**BOARD OF ZONING ADJUSTMENT
STAFF REPORT****Date: April 7, 2014****CASE NUMBER**

5882

Coward Hospitality Services, LLC

ACCESS AND MANEUVERING: Access and
Maneuvering Variances to allow the access and
maneuvering area for a dumpster to be within the public
right-of-way and not on-site in a B-4, General Business
District

SITE PLAN

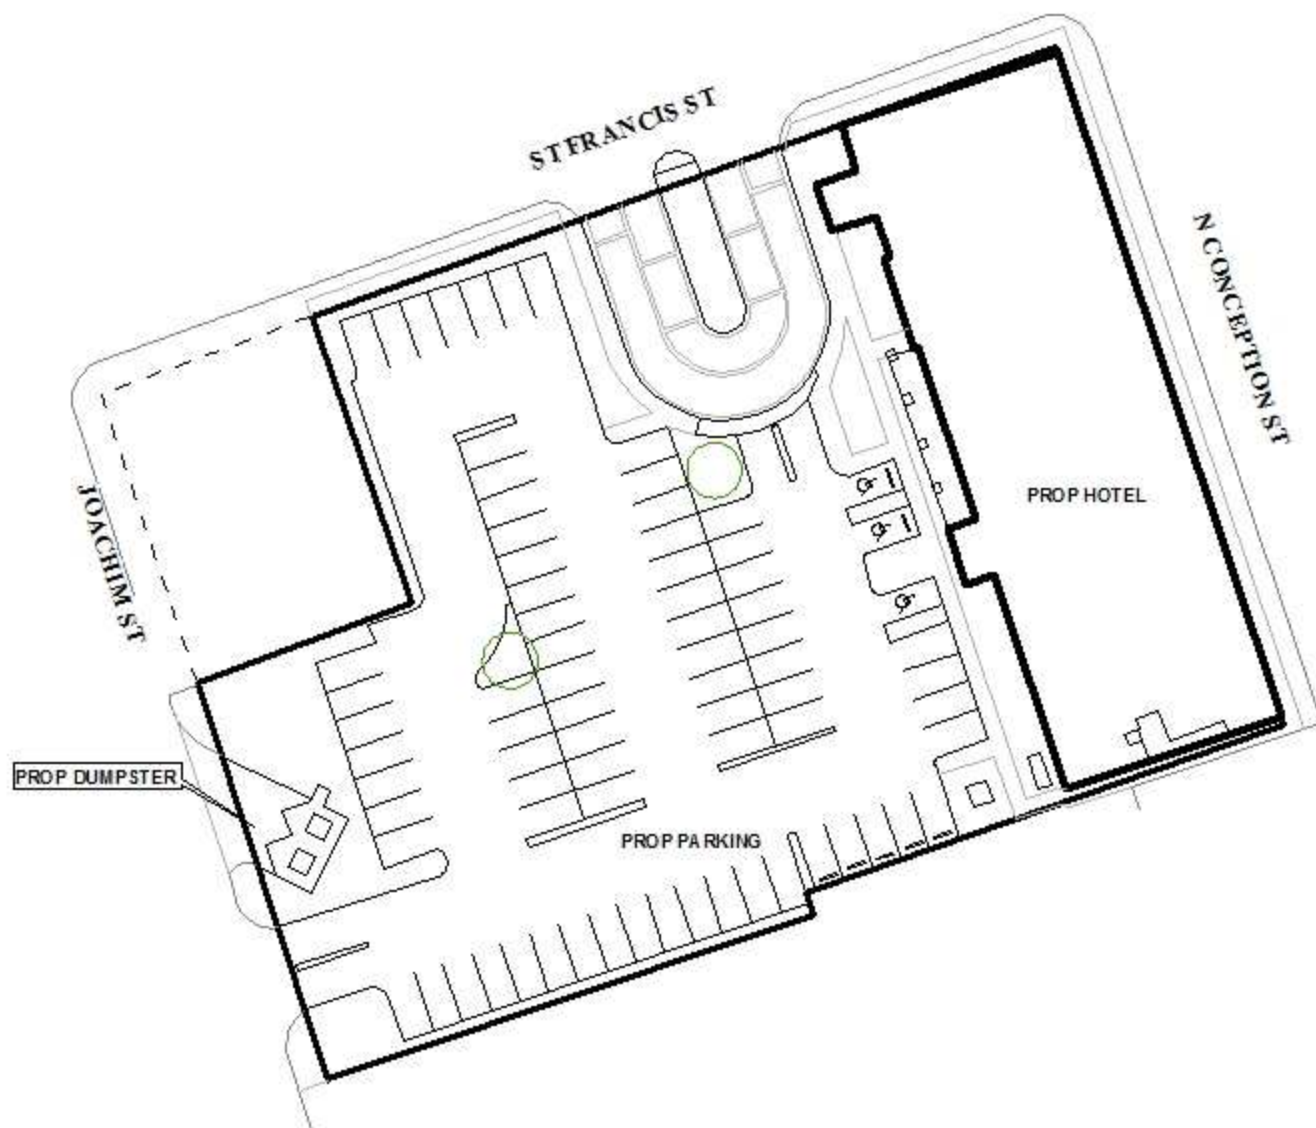
The proposed location of the dumpster will require the
garbage truck to be stopped within the roadway of Joachim Street, but should not extend beyond
the width of on-street parking. Exact design of the curb cut to be approved by Engineering and
Traffic Engineering and conform to AASHTO standards. Removal of the parking meter and any
conflicting parking space striping shall be coordinated with Traffic Engineering and at the
applicant's expense. Traffic stripe may not be painted over; grinding is required.

The site plan submitted with the application indicates that the dumpster enclosure will be within a landscaped area, however, the plan is not sufficiently detailed to determine if there will be trees or shrubs in the area of the dumpster to help mitigate any possible visual impacts. Thus the applicant should revise the site plan to provide understory trees in the vicinity of the dumpster, to be coordinated with Planning staff.

- 1) Dumpster to be enclosed on three sides and be connected to the sanitary sewer, as required by Section 64-4.D.9. of the Zoning Ordinance;
- 2) Dumpster enclosure to additionally have doors or gates for the frontage along North Joachim Street, and the gates are to remain closed except when the dumpsters are to be serviced;

- 3) Revision of the site plan to provide understory trees in the vicinity of the dumpster, to be coordinated with Planning staff;
- 4) Subject to Engineering comments (*A Right-of-Way permit, in full compliance with the City of Mobile Right-of-Way Construction and Administration Ordinance, latest edition, shall be required prior to any demolition or construction within the public right-of-way.*);
